Final Environmental Assessment

Wallooskee-Youngs Confluence Restoration Project

Bonneville Power Administration
DOE/EA-1974
July 2015

Changes to the EA

Figure 3-4: Cross Section Depicting Visual Impacts to Motorists Along OR 202

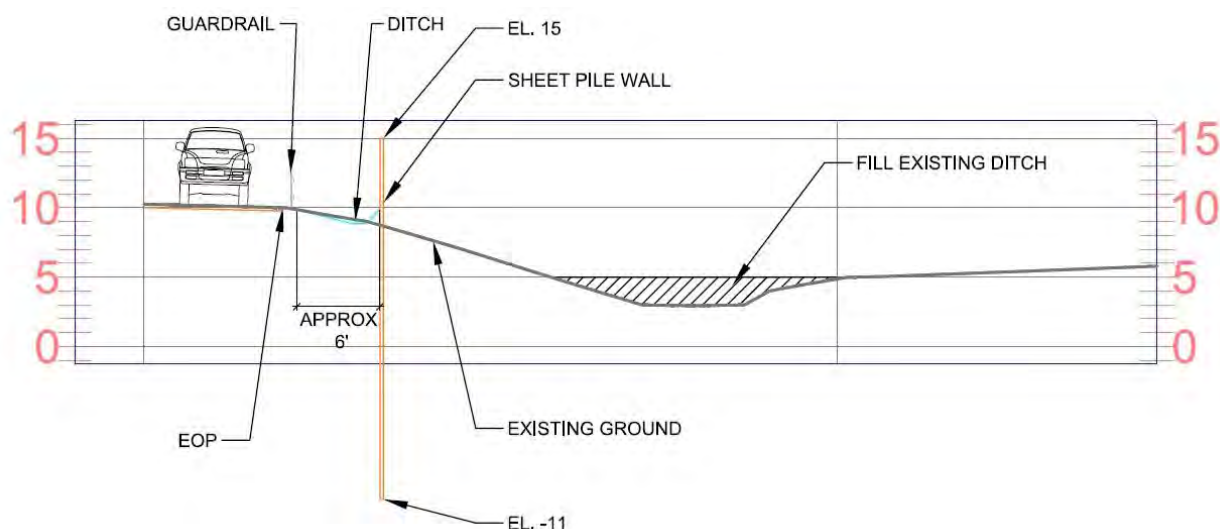
Additional analysis has been added to section 3.8.2.2 in aesthetics and visual resources regarding the final design for the sheet pile wall along OR 202 (Page 3-57, second paragraph).

The sheet pile wall would add an industrial element to the northern border of the site, visible as a long, but narrow, linear feature adjacent to the site. The sheet pile wall would be adjacent to OR 202, an existing linear manmade landscape feature and would blend into this feature when viewed from a distance. The properties to the south and west of OR 202, on the other side of the Wallooskee and Youngs rivers, would not likely be impacted due to the distance (0.8 mile) from the sheet pile wall. The exposed portion of the sheet pile wall, below OR 202, would be visible from within the project area or the Youngs River (greater than 0.3 mile away). The wall would also be visible from OR 202, and may block views for some motorists into the project site, as it would extend up to five feet above the road surface elevation along approximately 500 linear feet of OR 202. The sheet pile wall would extend along OR 202 for a total length of approximately 800 feet. The sheet pile wall's height would be approximately 4 to 5 feet above the road grade of OR 202 for 500 feet and would gradually decrease for the remaining 300 feet as the road climbs the upland knoll to the southeast. Photograph 3 shows the view from the northern tile shop driveway entrance along OR 202 into the project area. This photograph is located in the area where the sheet pile wall would extend 4 to 5 feet above the road grade. This is the low point of OR 202 and in this area the sheet pile wall would extend 4 to 5 feet above the pavement. A portion of the sheet pile wall would be screened by a guard rail; however, it is expected that the wall will would limit the views into the site for some motorists and patrons of the tile shop. A cross section depicting the maximum visual impact to motorists along OR 202 from the sheet pile wall is provided in below in Figure 3-4. The potential visual impacts of the sheet pile wall are considered moderate, since views of the wall are would be limited due to distances but views into the site from OR 202 would be impaired.
